# Work Order ID 107583

Item Name: Crosstube Turning Detail

DRAWING NO. D412-664-243	TITLE CROSSTUBE ASS'Y (412 HI AFT)	REV. E	DART AEROSPACE LTD ENGINEERING ORDER		D.E.O. NO. D412-664-243-E-2	SHEET NO. SHEET 1 OF 1	SCALE NTS
DRAWN <i>MP</i>	CHECKED <i>AS</i>	MFG. APPR. <i>RE</i>	APPROVED <i>MP</i>		DE APPR. <i>MP</i>		
DATE 11.09.07	DATE 11.09.19	DATE 11.09.19	DATE 11.09.19		DATE 11.09.19

DRAWING NO. D412-664-243	TITLE CROSSTUBE ASSEMBLY (412 HI AFT)	REV. E	DART AEROSPACE LTD ENGINEERING ORDER		D.E.O. NO. D412-664-243-E-4	SHEET NO. SHEET 1 OF 3	SCALE NTS
DRAWN <i>q</i>	CHECKED <i>A</i>	MFG. APPR. <i>A</i>	APPROVED <i>MD</i>		DE APPR. <i>MD</i>		
DATE 12.08.21	DATE 12.08.30	DATE 12.08.30	DATE 12/8/30		DATE 12.08.30

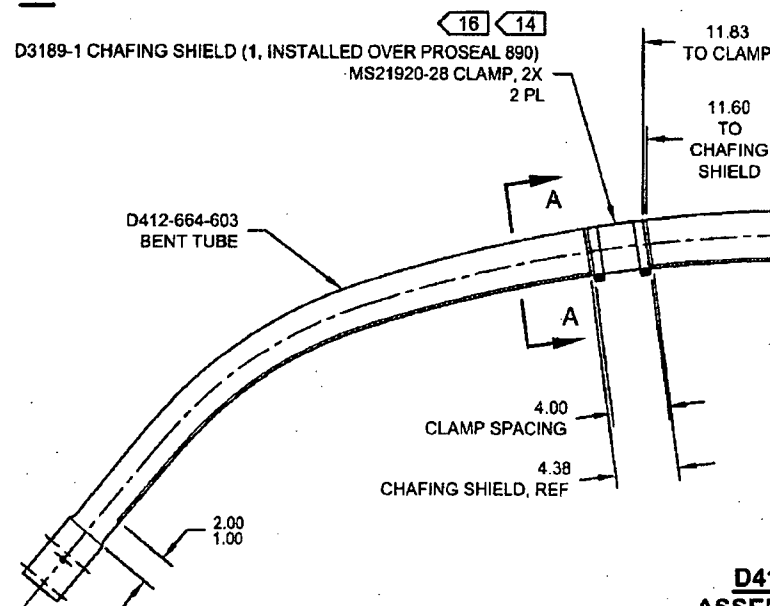
**PURPOSE:**

REMOVED ABRASION STRIP IN FAVOR OF A THIN LAYER OF PROSEAL 890. UPDATE INSTALLATION OF CHAFING SHIELDS AND REDUCE TORQUE TO 40-50 IN-LBS. THIS ENGINEERING ORDER SUPERCEDES DEO D412-664-243-E-1.

NOTES 2, 14, AND 16 ON SHEET 1 ARE AMENDED AS FOLLOWS:

**IS:**

- 2) FINISH: CHEMICAL CONVERSION COAT PER DART QSI 005 4.1  
PRIME INSIDE AND OUTSIDE PER DART QSI 005 4.2  
MASK UNDERSIDE OF CROSSTUBE AS SHOWN (HATCHED AREA)  
PAINT OUTSIDE PER DART QSI 005 4.2  
AFTER PAINTING, APPLY CLEAR COAT ON HATCHED AREA
- 14) APPLY A THIN COAT OF PROSEAL 890 ON INSIDE CONCAVE SURFACE OF D3189-1 CHAFING SHIELD AND LET CURE PER MANUFACTURER'S INSTRUCTIONS. INSTALL PROSEALED D3189-1 CHAFING SHIELD ONTO CROSSTUBE BY APPLYING A THIN COAT OF PROSEAL 890 ONTO CROSSTUBE. BE SURE TO ELIMINATE ANY AIR GAPS.
- 16) TORQUE CLAMPS ON D2896-1 SUPPORT 80 TO 100 IN-LB. **TORQUE CLAMPS ON D3189-1 CHAFING SHIELD 40 TO 50 IN-LB.** ENSURE AT LEAST 1.5 THREADS SHOWING IN SAFETY AND THAT NUT HAS NOT BOTTOMED-OUT AFTER TORQUING.
